## Attachment 7: Wollongong WDCP 2009 assessment

### CHAPTER D13 – WOLLONGONG CITY CENTRE

Figure 3.4: Active street frontages

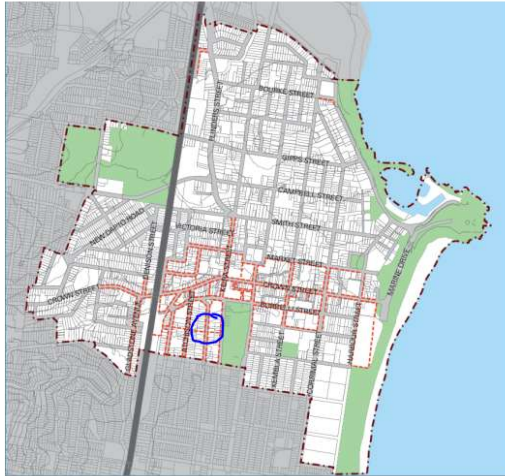
Objectives/controls	Comment	Compliance
<u>3.1 General</u>		
<u>3.2 Permeability</u> <p>An existing pedestrian link is identified along the northern side of 24 Kenny St in Figure 3.1</p>  <p>Figure 3.1: Permeability</p> <p>Legend:</p> <ul style="list-style-type: none"> <li>Lanes - Existing</li> <li>Lanes - Proposed</li> <li>Pedestrian links - Existing</li> </ul>	<p>There is no existing pedestrian link as shown in this figure. The site is not identified as a future link. Providing a link is not feasible given the existing buildings and approved developments to the west of the site.</p>	N/A
<u>3.3 Active street frontages</u> <p>Objectives:</p> <p>a) To promote pedestrian activity and safety in the public domain.</p> <p>b) To maximise active street fronts in Wollongong city centre.</p> <p>c) To define areas where active streets are required or are desirable.</p> <p>An active street frontage is required under Figure 3.4.</p>	<p>An active frontage is provided through the hotel entrance and bifold window opening to the café (no direct access).</p> <p>The site is flood affected therefore entrances at street level is a challenge. Given the site constraints, the design will result in good street activation.</p> <p>The residential lobby has been redesigned to be more generous and provide an improved street presence.</p>	Yes
